Access Compliance Report

Public Rights-of-Way

(Curb Ramps)

Intersection ID: 19251	Main Street: CHERRY_TRIPP_DR	Cross Street: VILLAGE_LAKE_DR	Location: SE
ADA ID: B34F4580C5F5	Ramp Type: PerpDiag	Initial Pass/Fail: Fail	Overall Compliance: No
Severity Score: 50			
Codes/Mitigation Info/Possible Solution		Field Measurements/Component Compliance

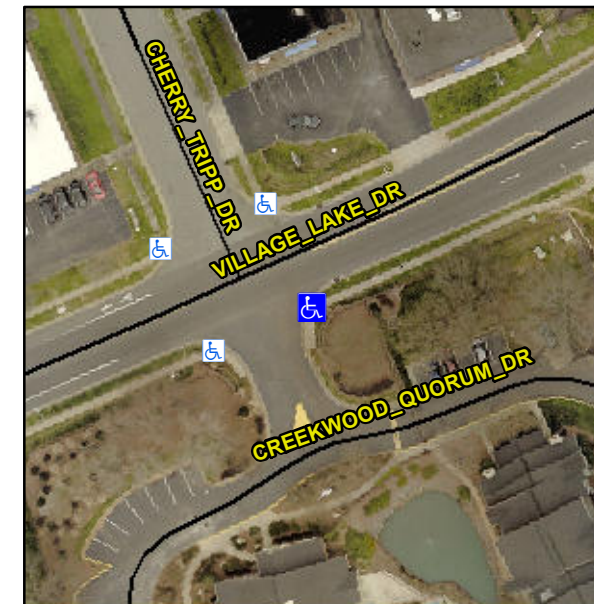
R304.2.2, R304.5.3

Compliance	Description	Data	Compliance	Description	Data
N/A	Ramp Length (in)	57.0	No	Ramp Slope (%)	12.2
Yes	Ramp Width (in)	48.0	No	Ramp XSlope (%)	8.4
N/A	Flare Type LT	N/A	N/A	Flare Type RT	N/A
N/A	Flare Slope LT (%)	N/A	N/A	Flare Slope RT (%)	N/A
N/A	Flare Traversable LT?	N/A	N/A	Flare Traversable RT?	N/A
N/A	Landing Length (in)	N/A	N/A	DWS Provided?	N/A
N/A	Landing Width (in)	N/A	N/A	DWS Contrast?	N/A
N/A	Landing Slope (%)	N/A	N/A	DWS Length (in)	N/A
N/A	Landing X Slope (%)	N/A	N/A	DWS Full Width?	N/A
N/A	Landing Curb? (Y/N)	N/A	N/A	DWS Offset (in)	N/A
N/A	Shared Landing?	N/A			
N/A	Gutter Ponding?	N/A	N/A	Gutter Slope (%)	N/A
N/A	Gutter Lip Ht (in)	N/A	N/A	Gutter X Slope (%)	N/A
N/A	Painted X Walk1?	No	N/A	Painted X Walk2?	No
	X Walk 1 Direction	To N		X Walk 2 Direction	To W
N/A	X Walk 1 Width (in)	N/A	N/A	X Walk 2 Width (in)	N/A
	X Walk 1 Slope (%)	7.1		X Walk 2 Slope (%)	0.5
	X Walk 1 X Slope (%)	0.6		X Walk 2 X Slope (%)	7.5

N/A	Ramp inside XWalk1?	N/A	N/A	Ramp inside XWalk2?	N/A
	Road Slope (%)	3.8	N/A	Clear Space?	N/A
	Road X Slope (%)	8.1	N/A	Clear Space to XWalk (in)	N/A
N/A	Any Obstructions?	N/A	N/A	Storm Grate/Utility Hazard?	N/A
	Obstruction Type			Storm Grate/Utility Type	
		N/A			N/A
		Yes		Surface Condition? (G/P)	Good

Remove & Replace Curb Ramp With Two New Directional Ramps or Equivalent.
